AGENDA
PLANNING COMMISSION REGULAR MEETING
Wednesday, January 17, 2024, at 6:00 PM

- 1. Appointment of Chair and Vice-Chair**
 - Legislative
 - Staff Presentation: Nicholas Wharton, Town Manager
- 2. Resolution PC-2024 01: A Resolution of the Town of Severance Planning Commission approving, with conditions, a Use by Special Review application on real property located with the Town of Severance, commonly known as 10845 County Road 74**
 - Legislative
 - Staff Presentation: Shani Porter, Town Planner
- 3. Resolution PC-2024 02: A Resolution of the Town of Severance Planning Commission approving, with conditions, a Site Plan application on real property located with the Town of Severance, commonly known as 10845 County Road 74**
 - Legislative
 - Staff Presentation: Shani Porter, Town Planner
- 4. Severance Police Station Site Plan**
 - Discussion

TOWN OF SEVERANCE POLICE FACILITY RENOVATION
SEVERANCE, CO

**SEVERANCE
POLICE
DEPARTMENT
RENOVATION**

DRAINAGE PLAN

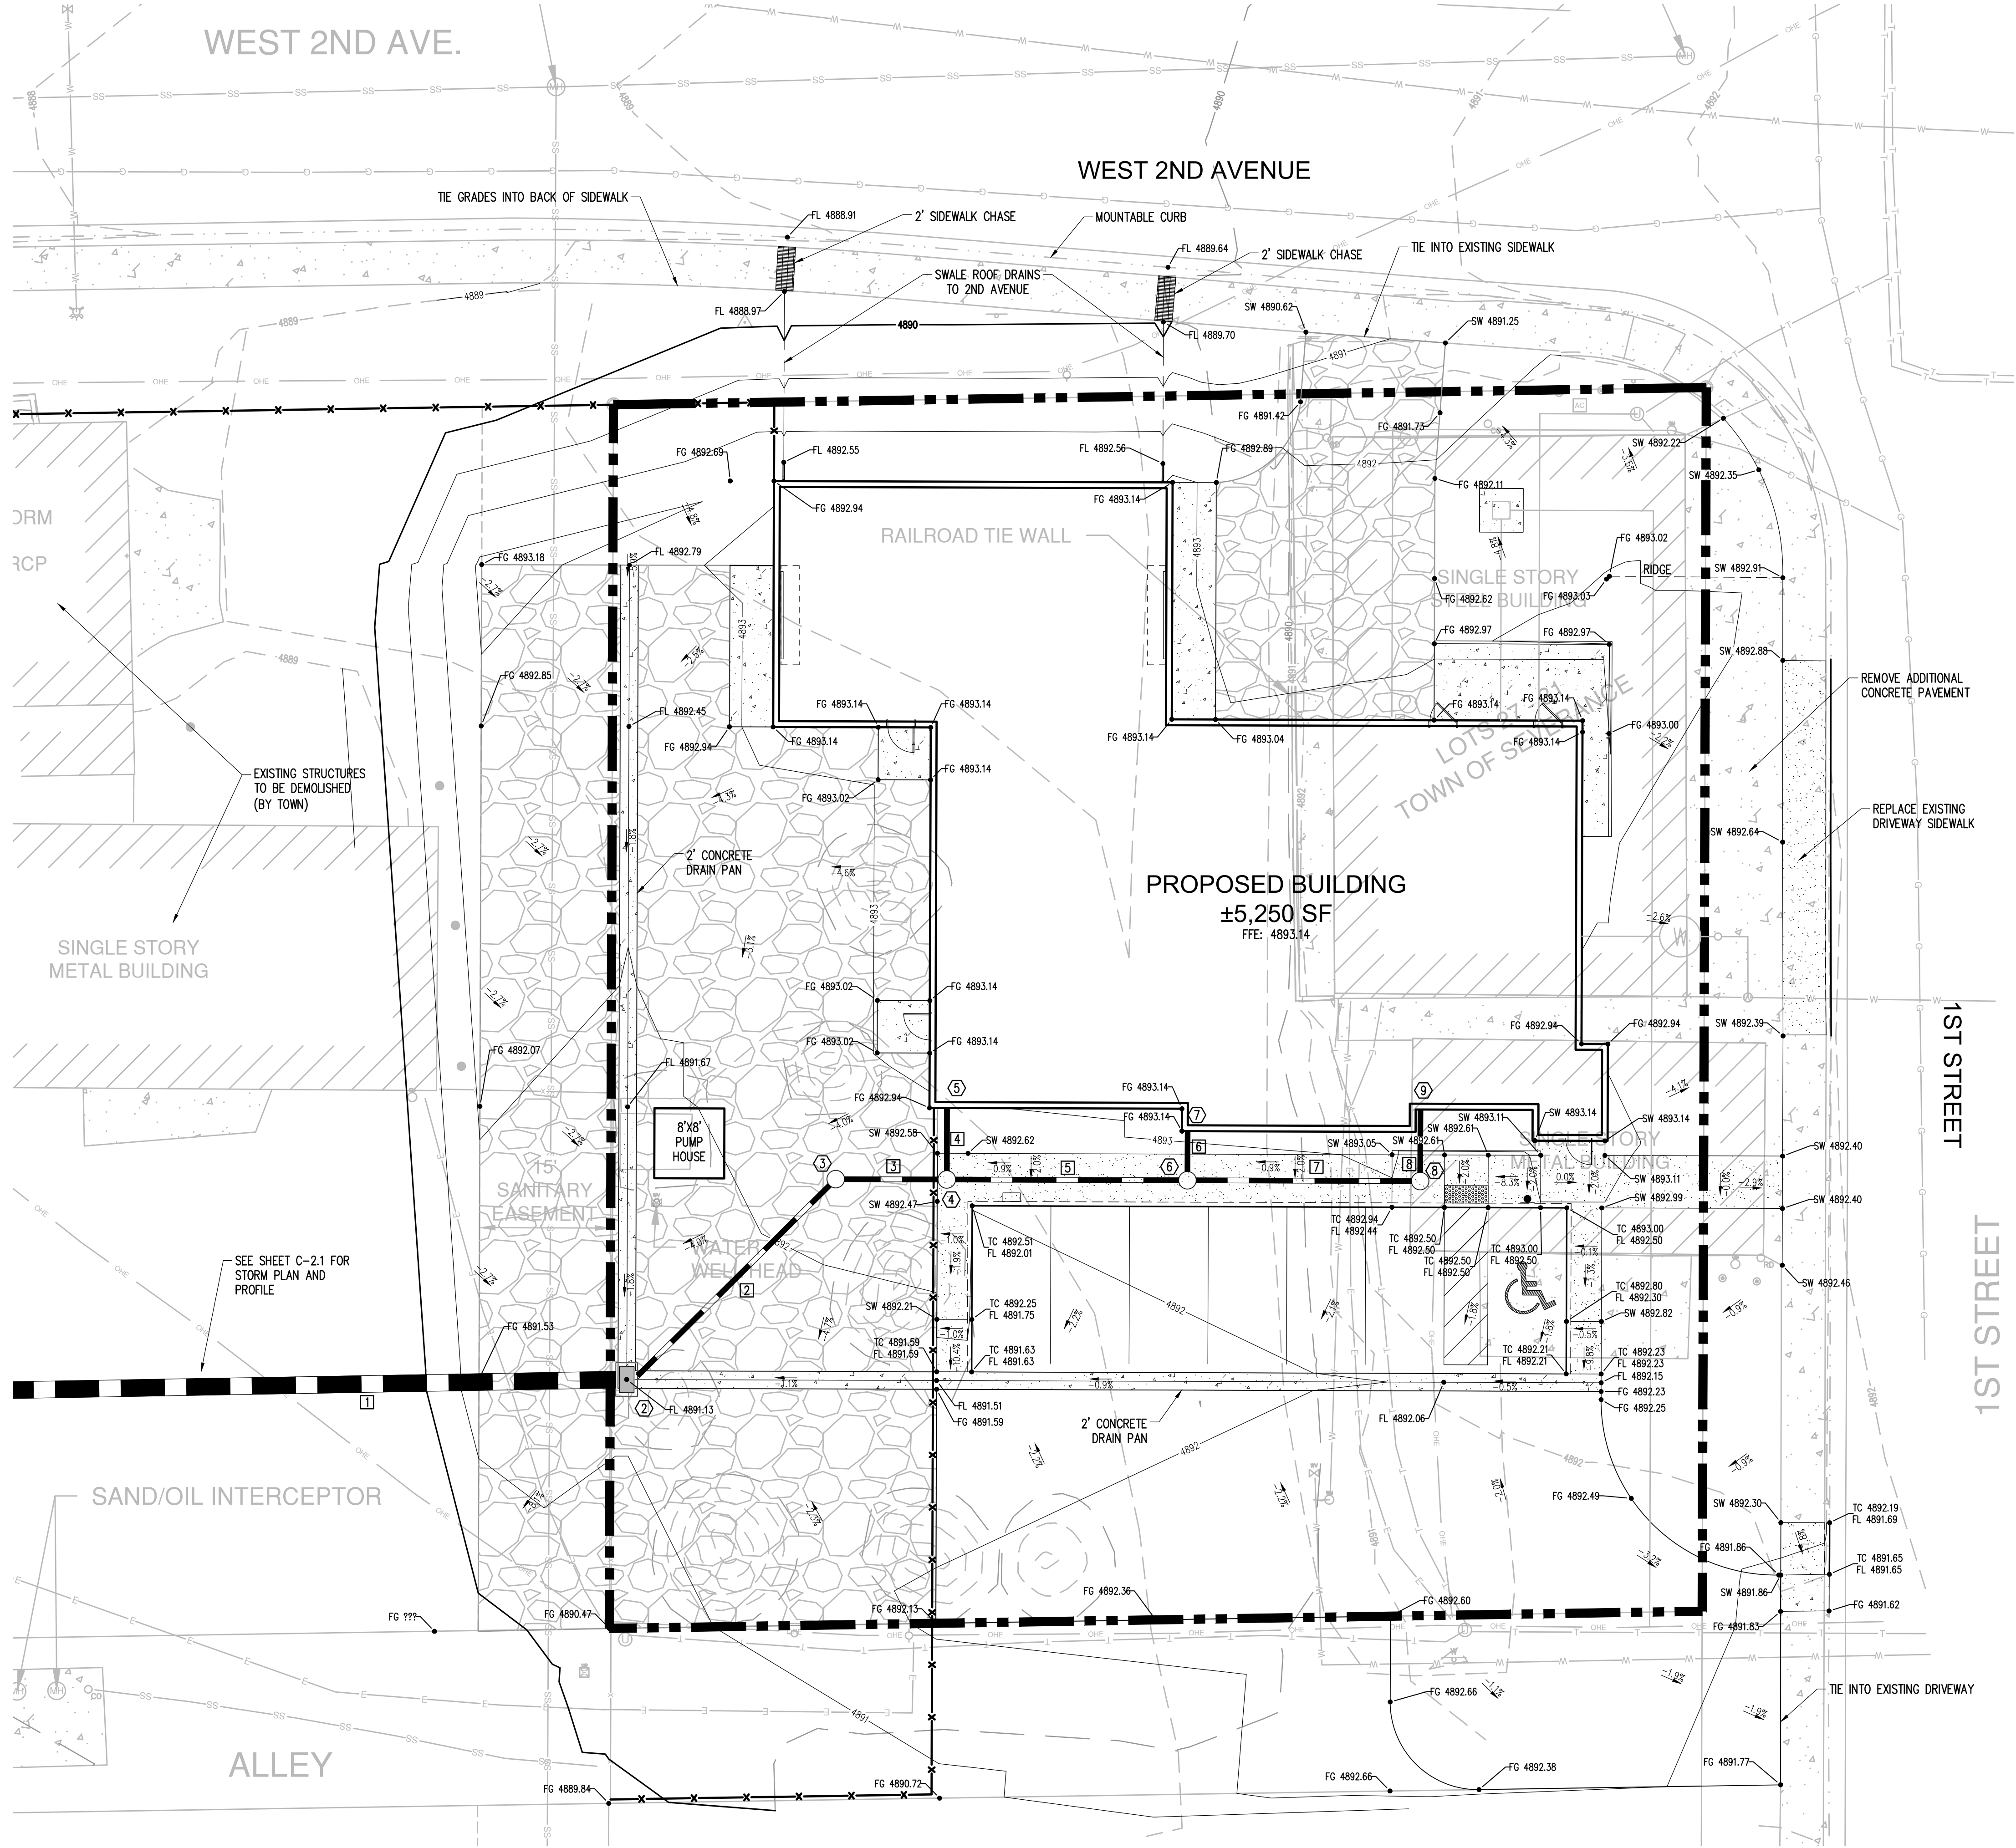
21. Sheet 3 (Grading Plan) – Are sidewalk chases needed? The slopes on gravel west of the property line are steep for police vehicles to traverse.
22. Sheet 4 (Storm P&P) – Storm pipe is within 4' of the existing building west of the site. Storm pipe may need to be shifted to the south for constructability. Show utility crossings.

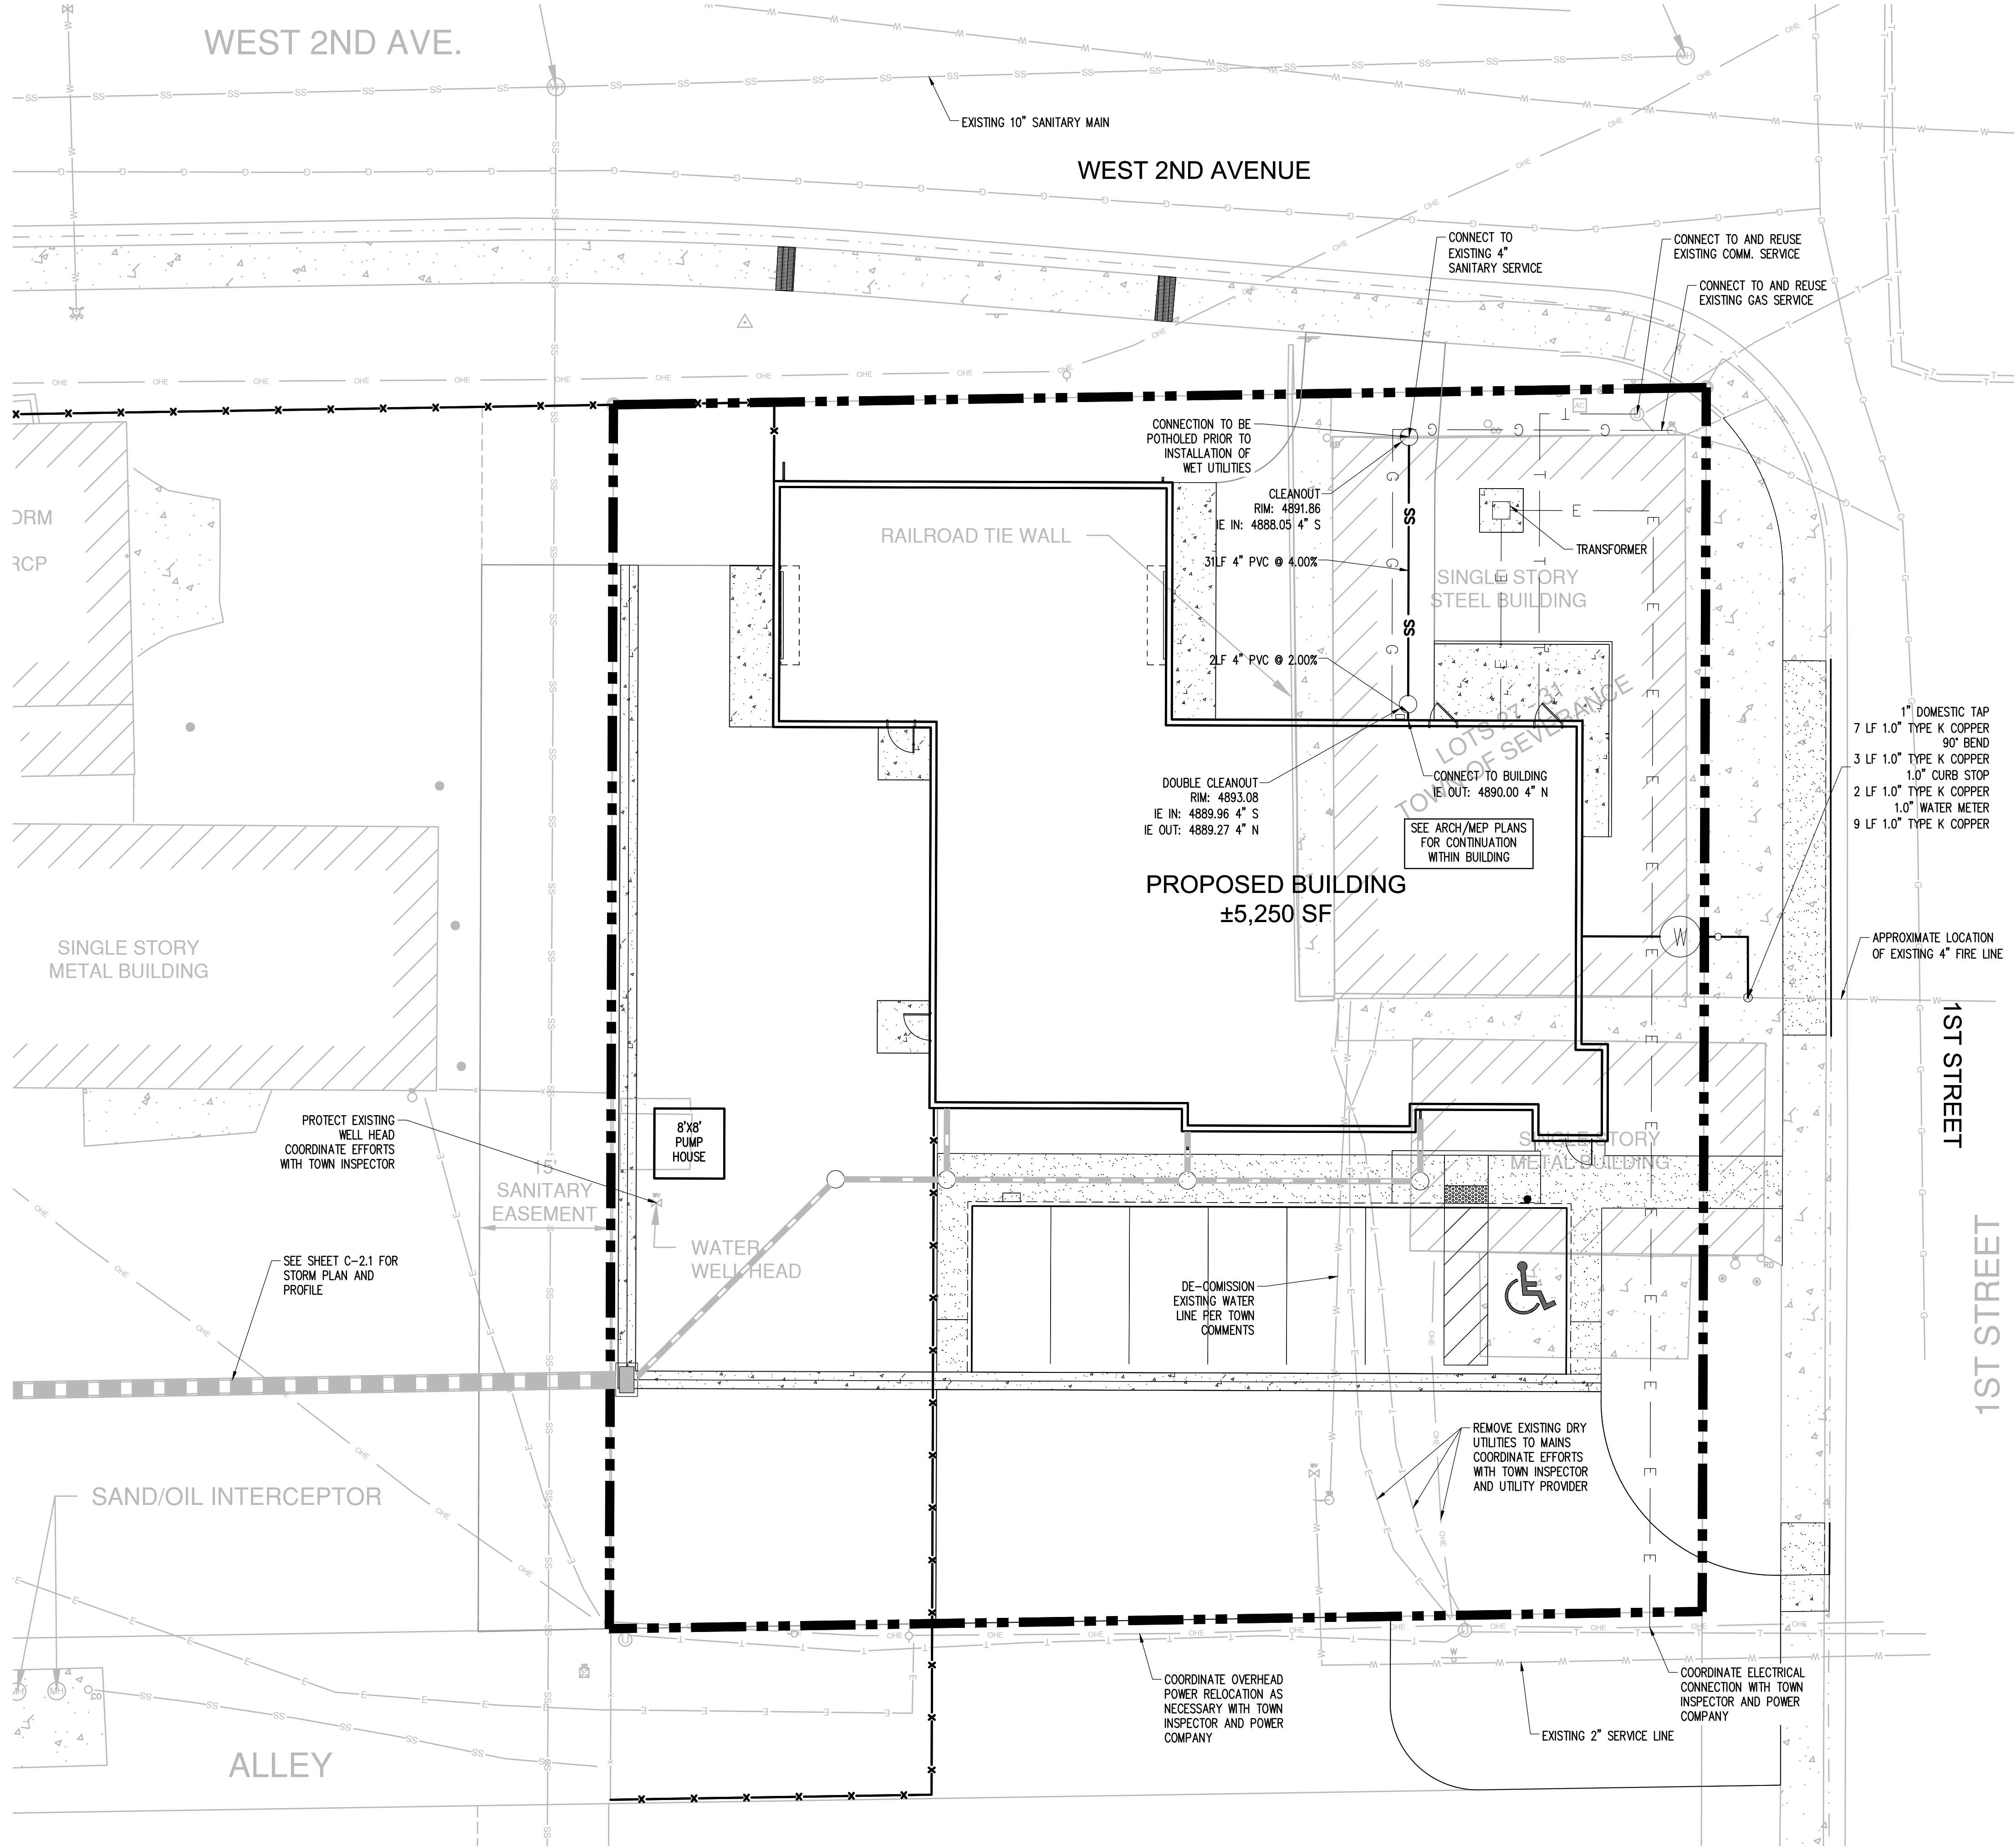
23. Sheet 5 (Utility Plan) – Update location of existing water and sanitary sewer lines and services based on information provided with these comments. Determine if the existing sanitary service, water service, and fire line can be used (based on needed size and location). If the existing services cannot be used, these services must be abandoned at the main and the new water service and/or fire line should connect to the new water main in 2nd Avenue. Provide 10' utility separation. We understand the building will require a fire sprinkler system.

24. Sheet 5 (Utility Plan, Water Meter) – The proposed water meter is called as a 1.25" which is not a standard size. The Town's standard water meter/tap sizes are ¾", 1", and 1.5".
